Access Compliance Report

Public Rights-of-Way

Intersection ID: 10559	Main Street: CHARLES_AV	Cross Street: E_35TH_ST	Location: N
ADA ID: ABF4D923B94E	Ramp Type: PerpDiag	Initial Pass/Fail: Fail	Overall Compliance: No
		Severity Score: 10

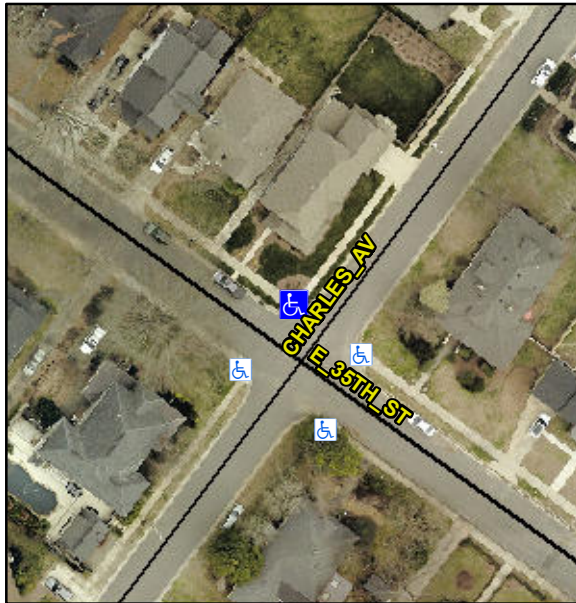
Not Found, R304.5.1, R304.5.3

Compliance	Description	Data	Compliance	Description	Data
N/A	Ramp Length (in)	68.0	Yes	Ramp Slope (%)	5.2
No	Ramp Width (in)	44.0	No	Ramp XSlope (%)	2.2
N/A	Flare Type LT	N/A	N/A	Flare Type RT	N/A
N/A	Flare Slope LT (%)	N/A	N/A	Flare Slope RT (%)	N/A
N/A	Flare Traversable LT?	N/A	N/A	Flare Traversable RT?	N/A
N/A	Landing Length (in)	N/A	N/A	DWS Provided?	N/A
N/A	Landing Width (in)	N/A	N/A	DWS Contrast?	N/A
N/A	Landing Slope (%)	N/A	N/A	DWS Length (in)	N/A
N/A	Landing X Slope (%)	N/A	N/A	DWS Full Width?	N/A
N/A	Landing Curb? (Y/N)	N/A	N/A	DWS Offset (in)	N/A
N/A	Shared Landing?	N/A			
N/A	Gutter Ponding?	N/A	N/A	Gutter Slope (%)	N/A
N/A	Gutter Lip Ht (in)	N/A	N/A	Gutter X Slope (%)	N/A
N/A	Painted X Walk1?	No	N/A	Painted X Walk2?	No
	X Walk 1 Direction	To SW		X Walk 2 Direction	To SE
N/A	X Walk 1 Width (in)	N/A	N/A	X Walk 2 Width (in)	N/A
	X Walk 1 Slope (%)	1.7		X Walk 2 Slope (%)	0.3
	X Walk 1 X Slope (%)	1.7		X Walk 2 X Slope (%)	1.3

Remove & Replace Curb Ramp With Two New Directional Ramps or Equivalent.
